Revision F 03.12.16  
Block paving removed from the tree protection zone at T10  
Revision Q 08.12.16  
Gravel restricted to 20% of the root protection area of all the trees

Bay Tree Cottage

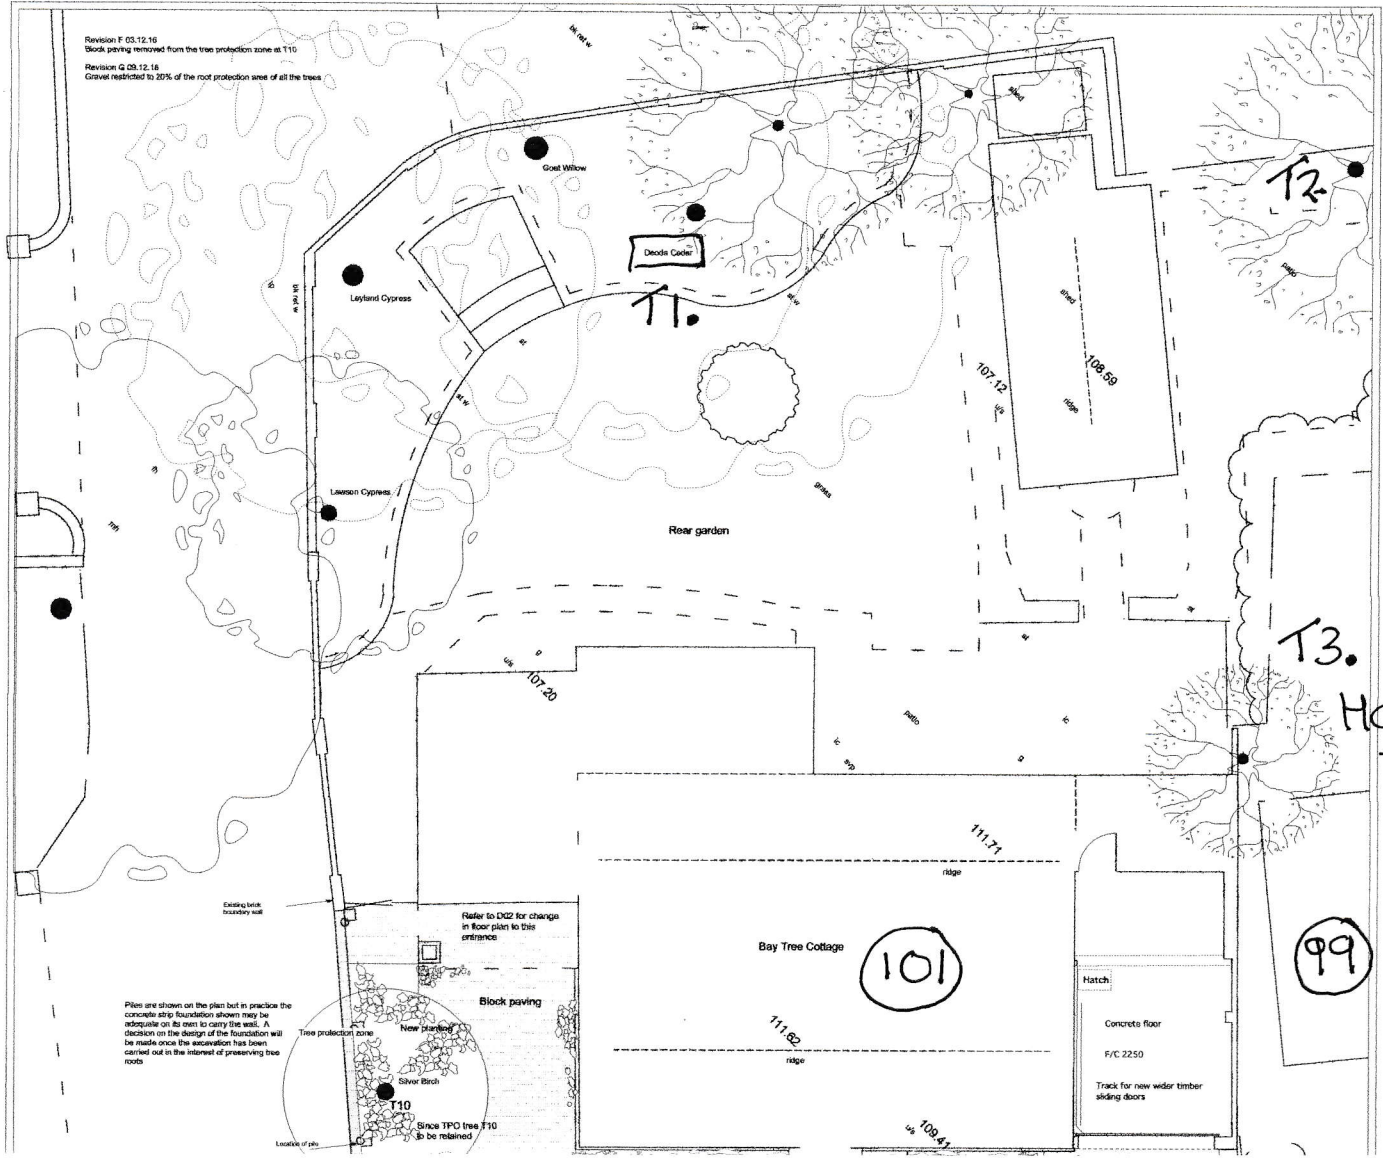
Piles are shown on the plan but in practice the concrete strip foundation shown may be adequate on its own to carry the wall. A decision on the design of the foundation will be made once the excavation has been carried out in the interest of preserving tree roots
